**Item 5C  
Attachment 11**

**RE: Waterstone South Rezoning & Annexation**

**RE: Waterstone South Annexation and Rezoning – 2<sup>nd</sup> Submittal**

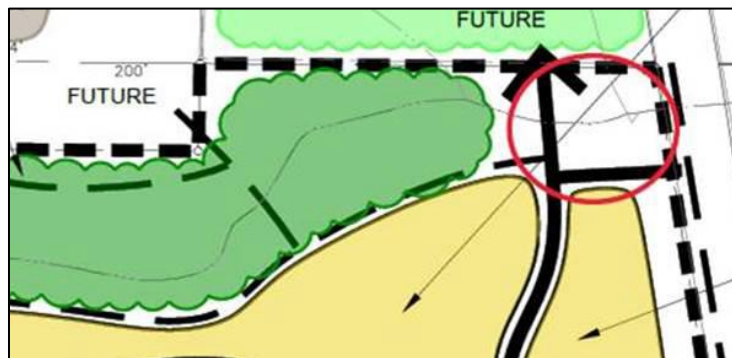
- A. On the master plan, why is the area, circled in red below, not shown as containing undisturbed area? This area contains protected riparian buffers and jurisdictional streams.
